**SUBJECT:** Sixth Five-Year Remedy Review Report for Savannah River Site Operable Units with Operating Equipment (U) Aiken, South Carolina (SRNS-RP-2022-00468, Revision 1, June 2023) (Redline Pages), Sixth Five-Year Remedy Review Report for SRS Operable Units with Operating Equipment Fact Sheet (SRNS-RP-2022-00488, June 2023) (Redline), and Savannah River Site's Responses to the Regulatory Comments on the Revision 0 Document, SEMS Number: 00

**SRS Responses to U.S. Environmental Protection Agency Comments on the  
Sixth Five-Year Remedy Review Report for Savannah River Site Operable Units with  
Operating Equipment (U), SRNS-RP-2022-00468, Revision 0, December 2022**

Figure L-7. 2022 PBRP OU Optimized Monitoring Network

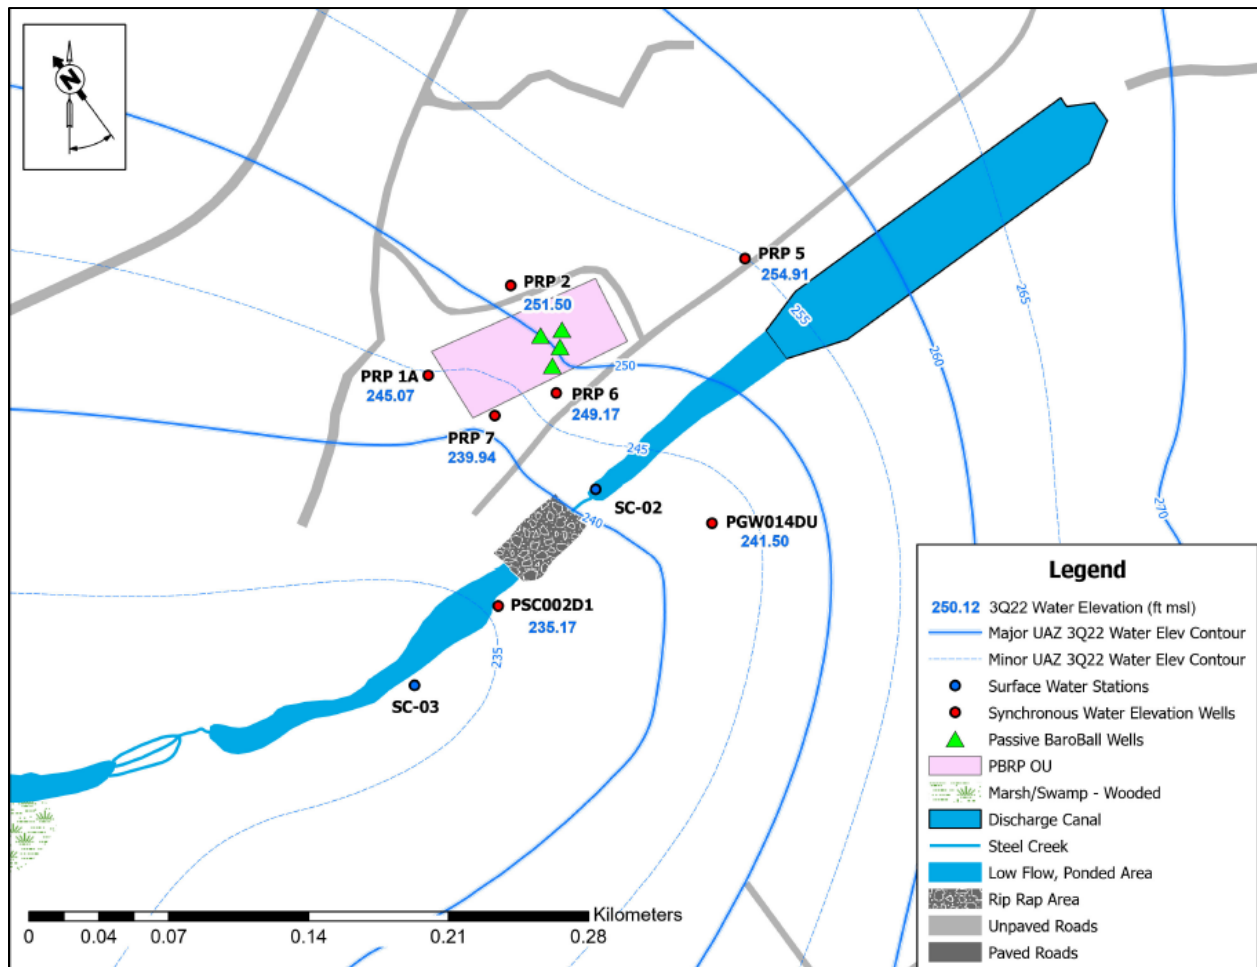
- 27. Appendix L, Figure L-7, 2022 PBRP OU Optimized Monitoring Network, Page L-21 of L-36:** This figure shows upper aquifer zone (UAZ) potentiometric surface contour lines; however, the groundwater elevations that the contour lines represent are not defined. In addition, the groundwater elevations used to generate these contours are not provided and it is unclear when the groundwater elevation data were collected. *Please revise Figure L-7 to include the UAZ potentiometric surface contour elevations, the groundwater elevations measured at the wells depicted, and note in the Legend when the data were collected.*

**Figure L-7 will be revised to include the UAZ potentiometric surface contour elevations, and the groundwater elevations measured at the wells depicted on the figure. The figure is shown at the end of this document. Text will also be added to indicate the data were collected in 3Q2022.**

Figure L-10. Time Series plot of 1,4-Dioxane at Wells PRP 5, PRP 6, PRP 7

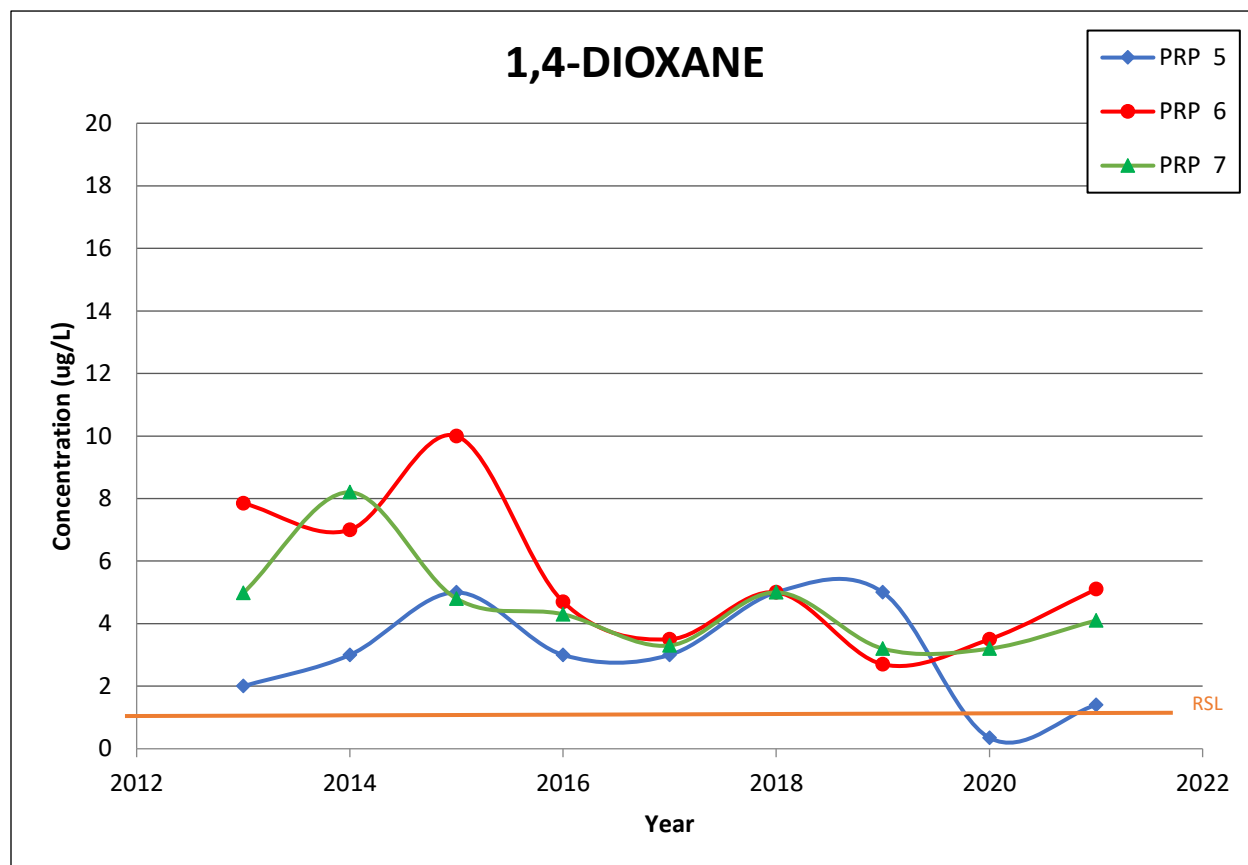
- 25. Appendix L, Section V, Progress Since Last Review, Page L-8 of L-36 and Section VI, Five-Year Review Process, Page L-9 of L-36:** Section V indicates there is uncertainty in the extent of 1,4-dioxane contamination and additional surface-water sampling is necessary; however, this data gap is not further discussed in Appendix L. For example, Section VI does not discuss the 1,4-dioxane data or provide the time-series graph (e.g., in the Data Review) so it is unclear if concentrations of 1,4-dioxane are increasing similar to TCE. In addition, Section VII (Technical Assessment) states that groundwater monitoring continues to be effective in assessing groundwater contamination beneath the PBRP OU. Furthermore, Section VIII (Issues) does not identify the uncertainty in the extent of 1,4-dioxane contamination as an issue at the site. *Please revise Appendix L to discuss any trends in the*
-

Time-Series Plots for 1,1-DCE and TCE were included in Figure L-8; therefore, Time-Series Plots for 1,4-Dioxane will be added as Figure L-10 and referenced in the revised text in Section VII as shown below. Figure L-10 is included at the end of this document.

“...will be increased to semi-annual at PRP 6 and PRP 7. 1,4-Dioxane concentrations continue to be at a steady state in all wells indicating no observed trend of increasing or decreasing concentrations but exhibit concentrations above the RSL (Figure L-10). The background well, PRP 5, remains non-detect for all VOC analyses.”
